Construction Change Directive

PROJECT: *(name and address)*
Highland Township Fire Station 2
PIA #18-122B

CCD INFORMATION:
Directive Number: 001
Date: July 13, 2021

“EXHIBIT A” – CCD NO. 1

C-5 SITE WATER MAIN PROFILES

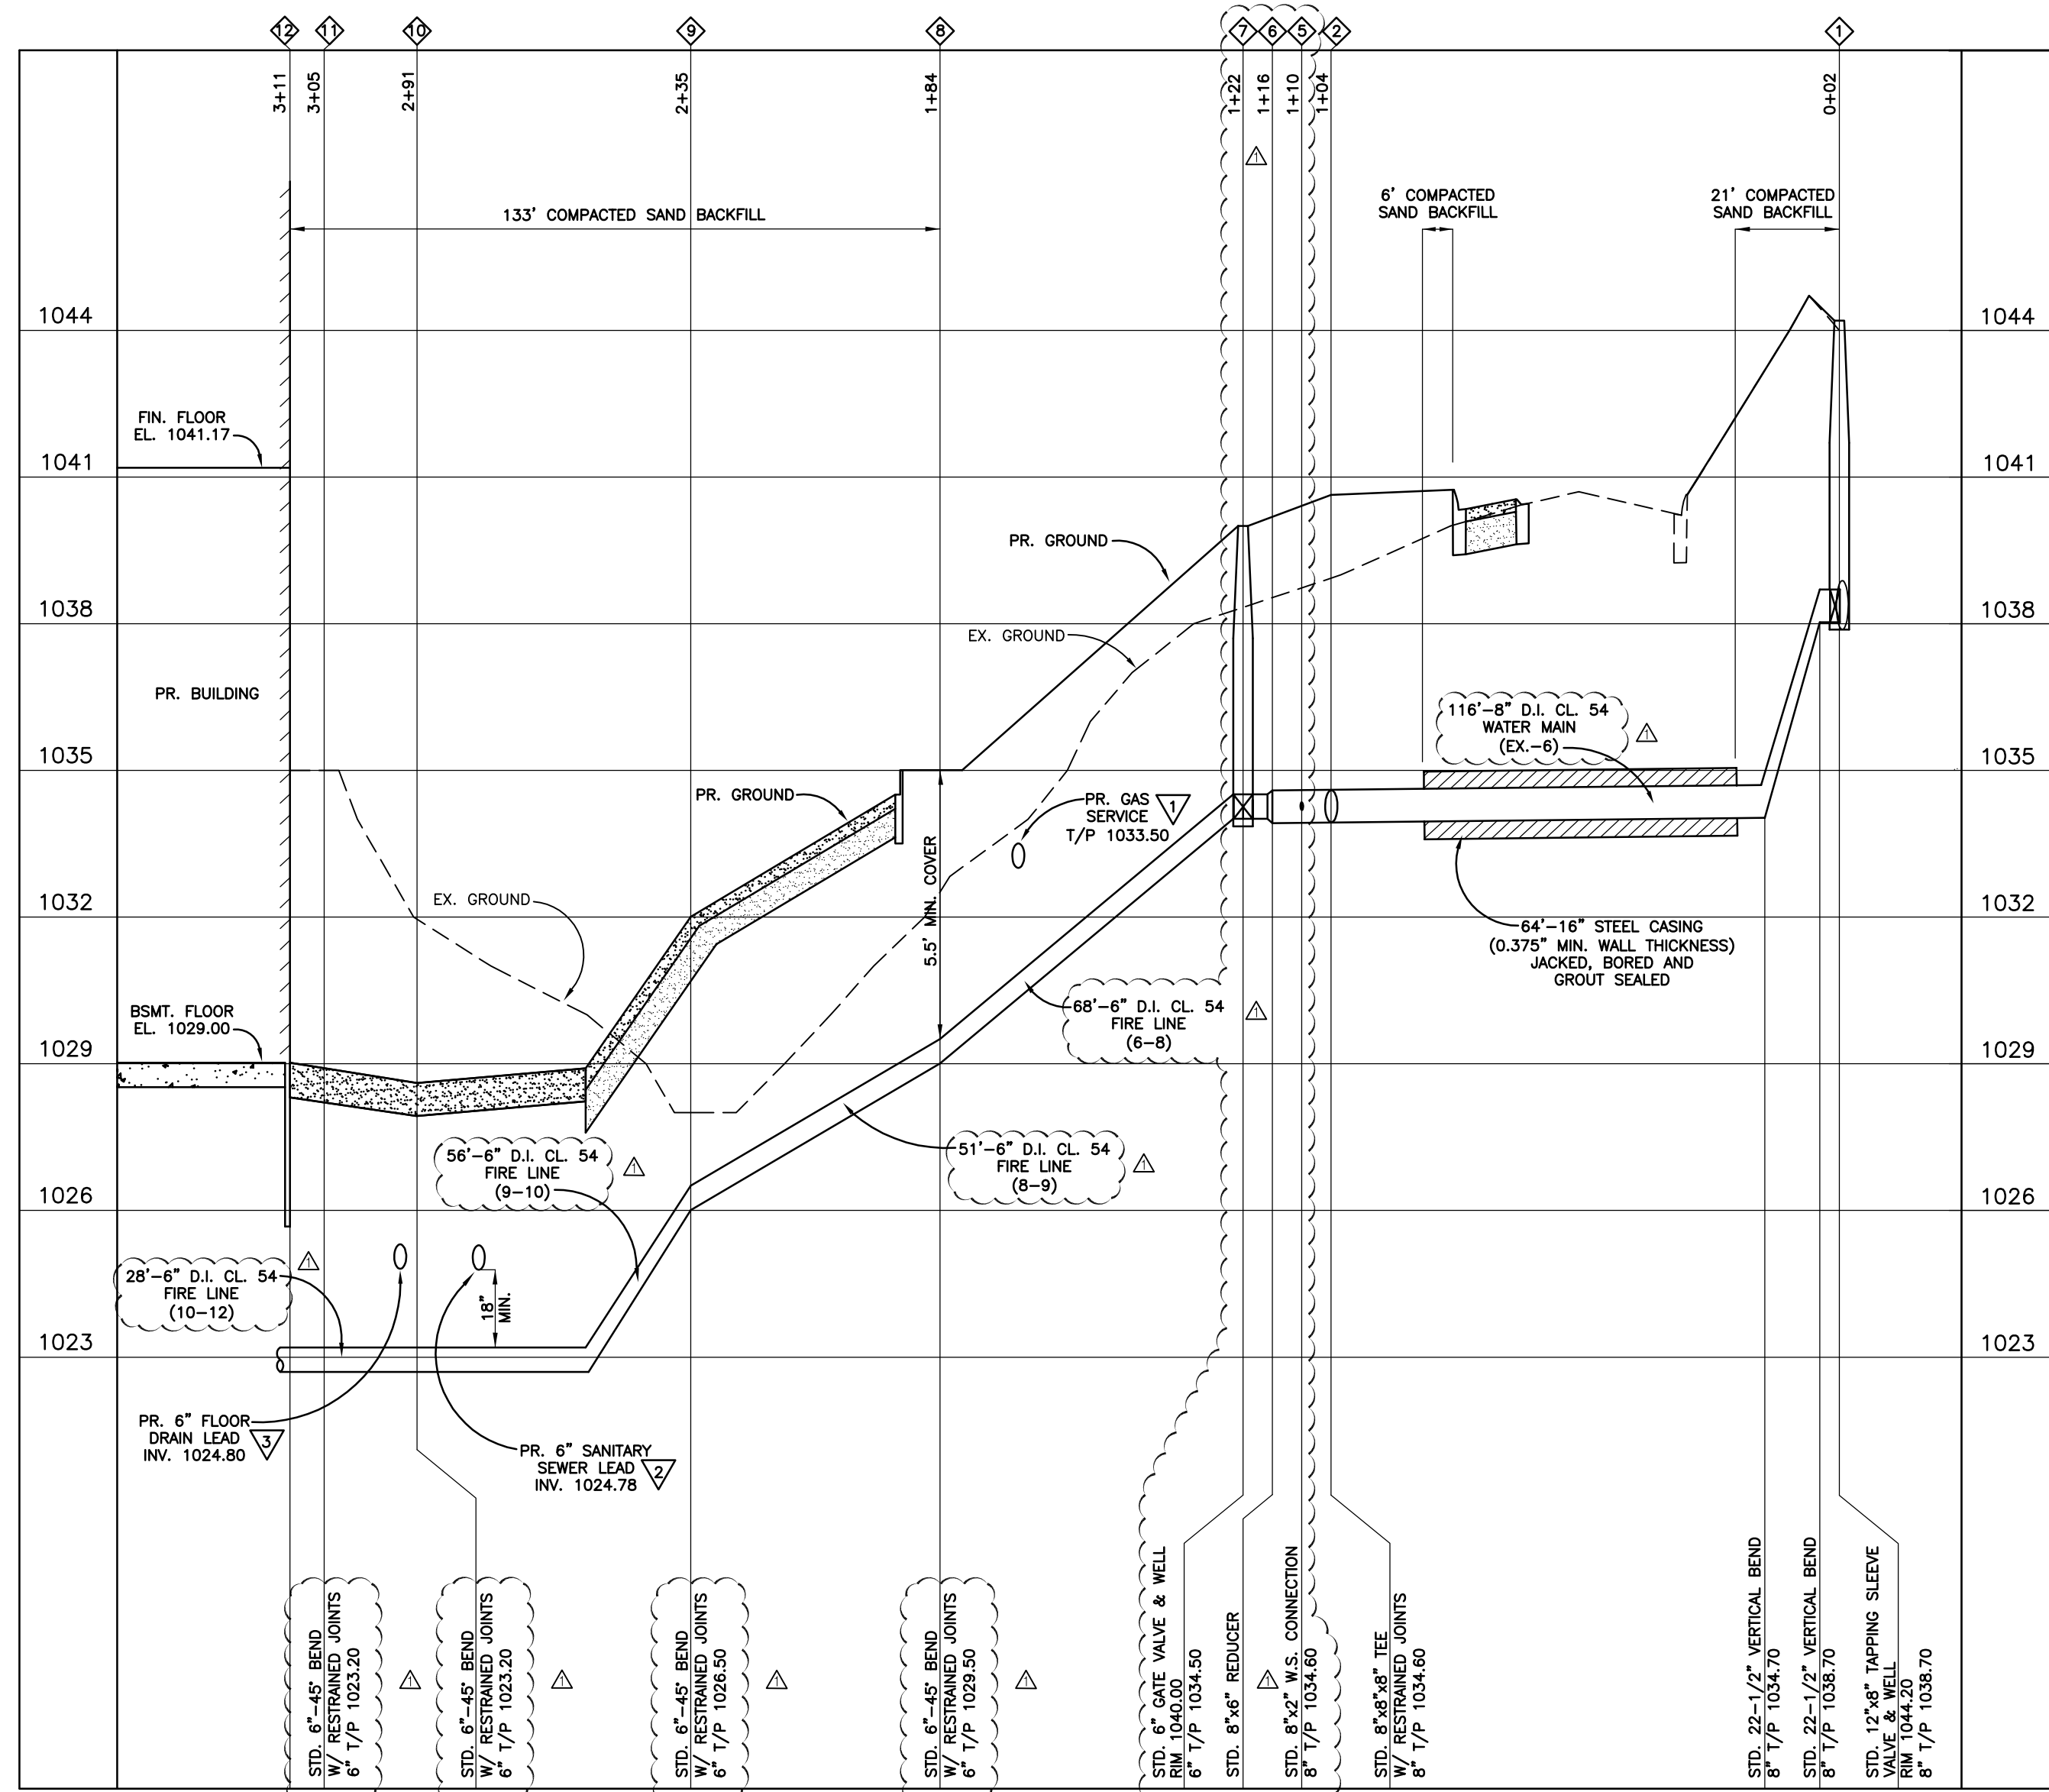
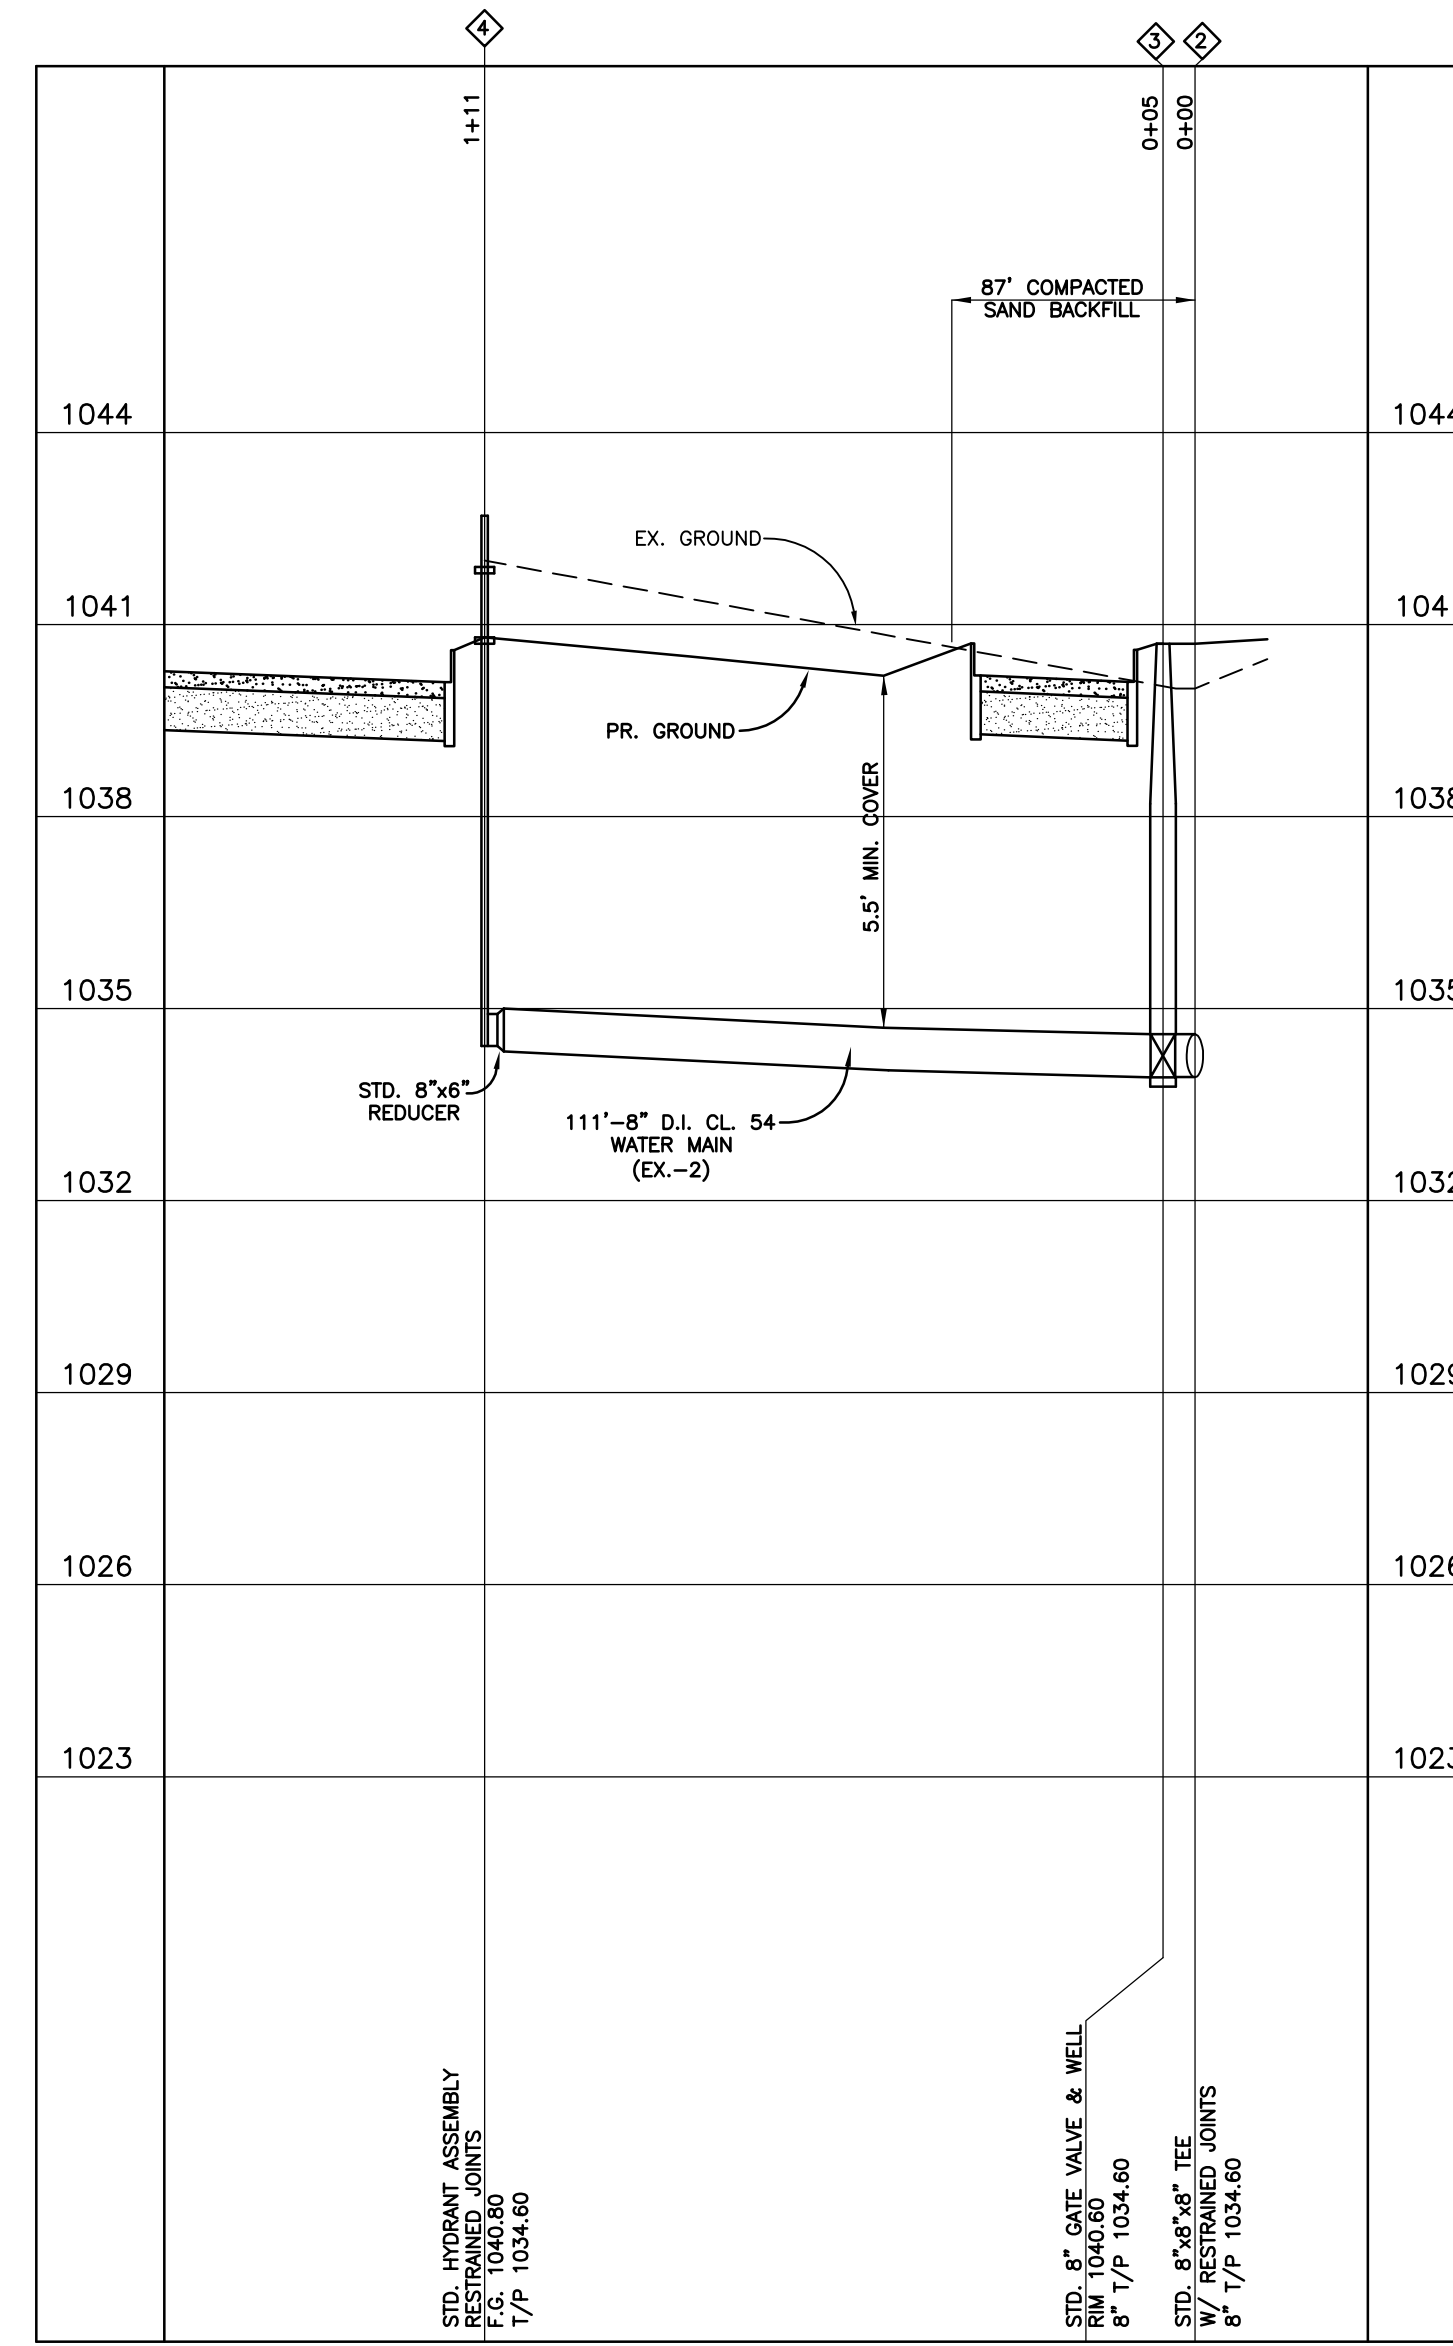
- A. Replaced single 8" water lead south of hydrant lead tee with separate 2" water service and 6" fire line.
